WEST BAY
SANITARY DISTRICT
SAN MATEO COUNTY, CALIFORNIA

FLOW EQUALIZATION AND RESOURCE RECOVERY FACILITY LEVEE
IMPROVEMENTS PROJECT
Menlo Park, California

ADDENDUM #2

WBSD Project No. 1762.0

SHEET	C1.2
JOB NO.	1079

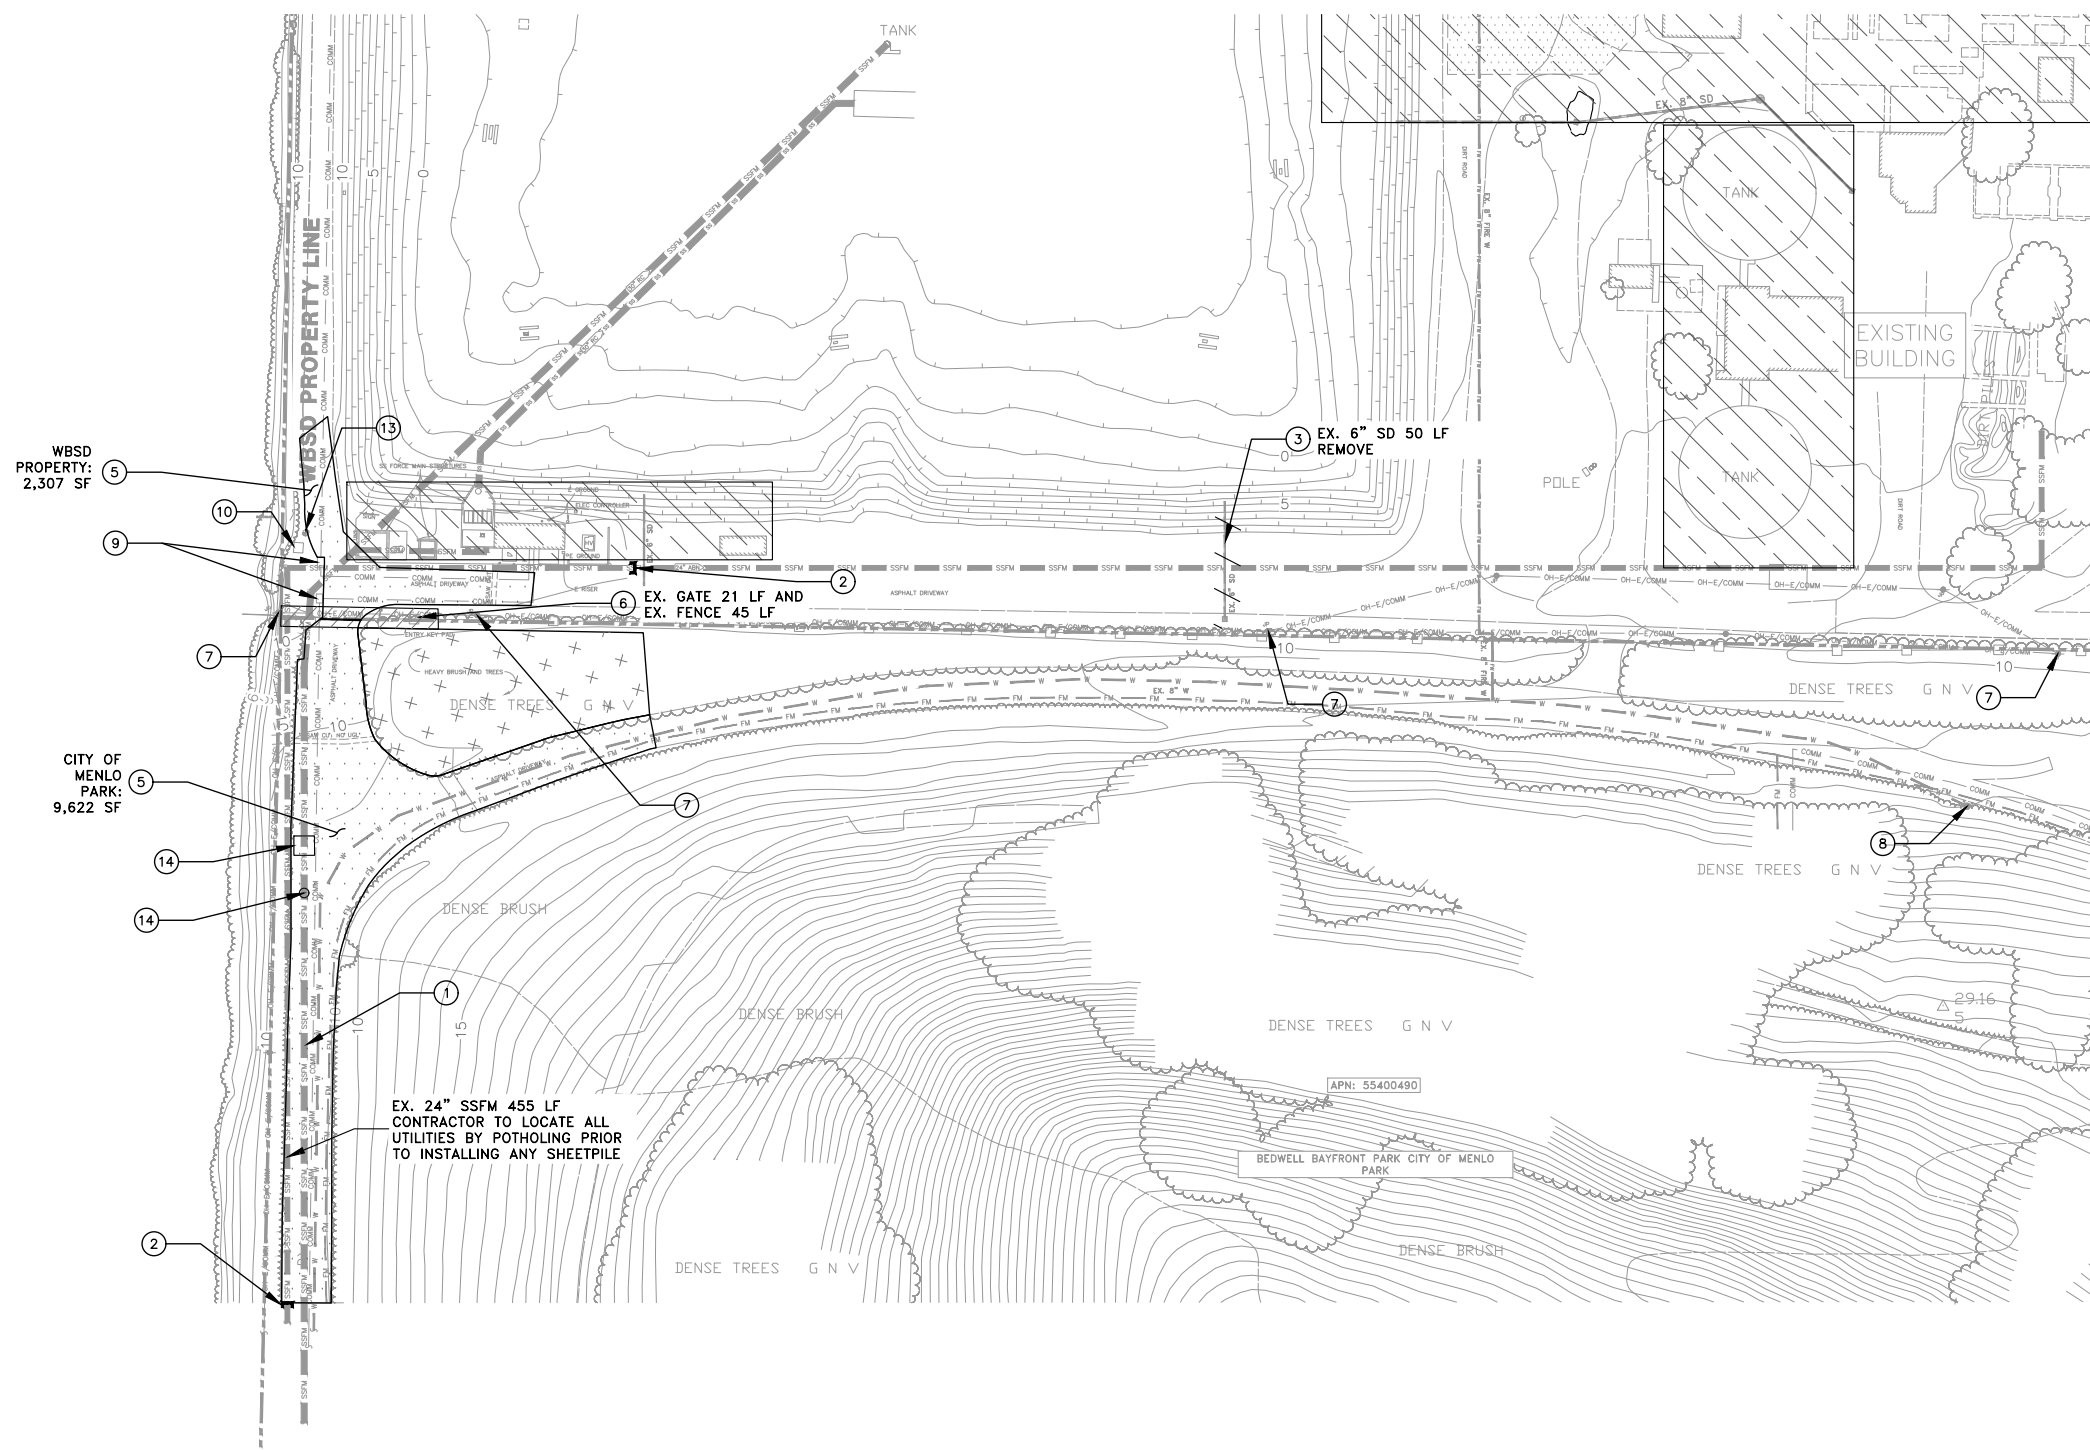
1. On Sheet C1.2, note 2 calls out for a cap on an existing sanitary sewer forcemain utility. Please confirm size of existing sanitary sewer forcemain.

REPLACE Pages C1.2 with C1.2 – Addendum 2. Demolition Key Note 2 revised.

- a. The existing sanitary sewer forcemain is a 24-inch pipeline. Please see revised Sheet C1.2-Addendum 2.
2. On Sheet C13.0, what size is the new storm drainage system?

- ② INSTALL CAP FOR 24" FORCE MAIN.
- ③ REMOVE EXISTING UTILITY.
- ④ REMOVE CONCRETE.
- ⑤ REMOVE EXISTING AC PAVEMENT AND BASE.
- ⑥ EXISTING GATE AND/OR FENCE TO BE REMOVED.

SHEET
C13.0

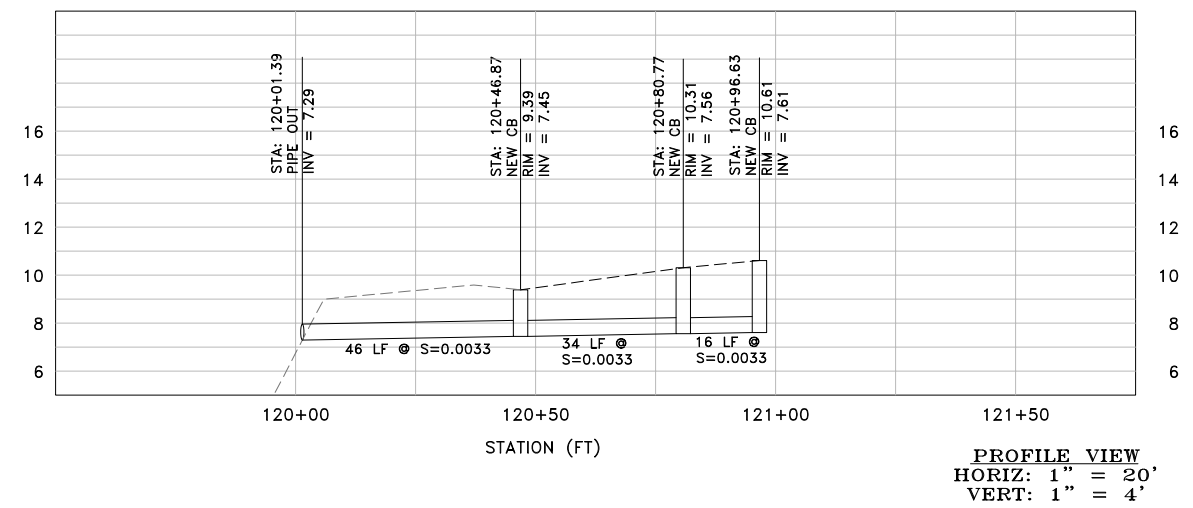
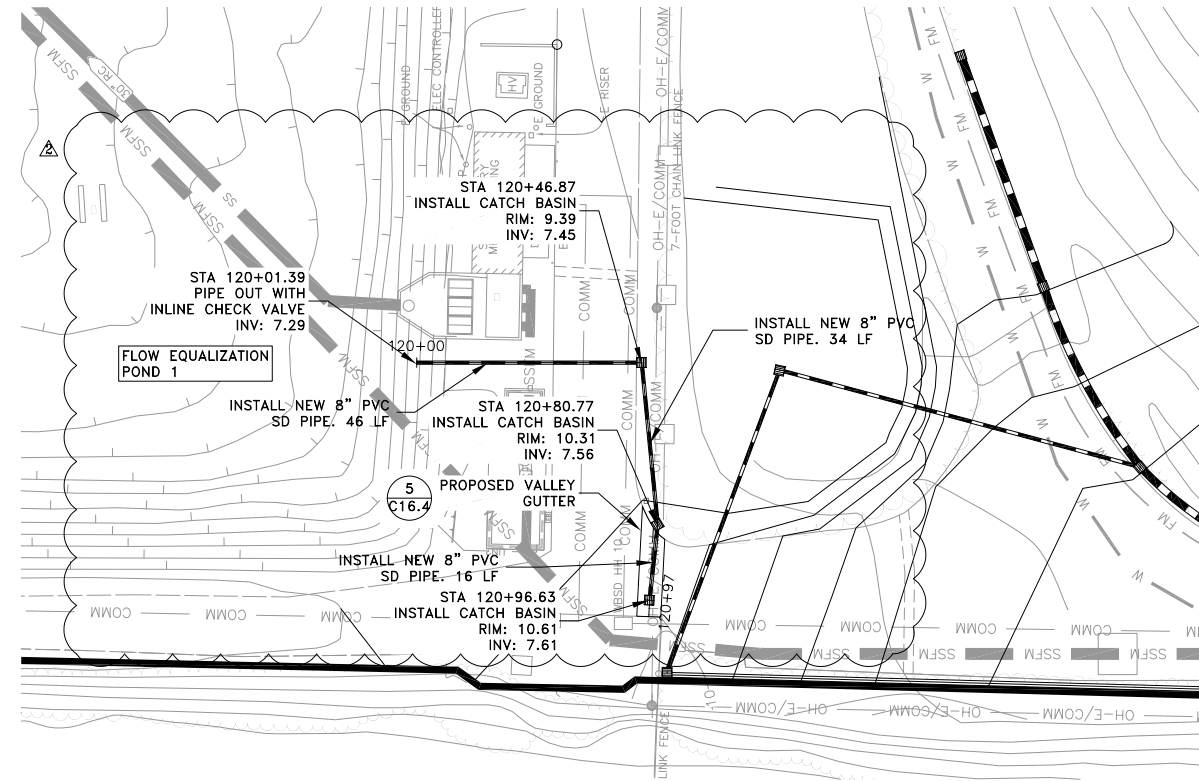
REPLACE Pages C13.0 with C13.0 – Addendum 2. Pipe size and linear footage added to sheet.

- a. The proposed size for the storm drainage system on Sheet C13.0 is 8" PVC C900. Please see revised Sheet C13.0-Addendum 2.
3. Are PZ style sheet pile walls the only allowable style or can the sheet piles be an equivalent product?
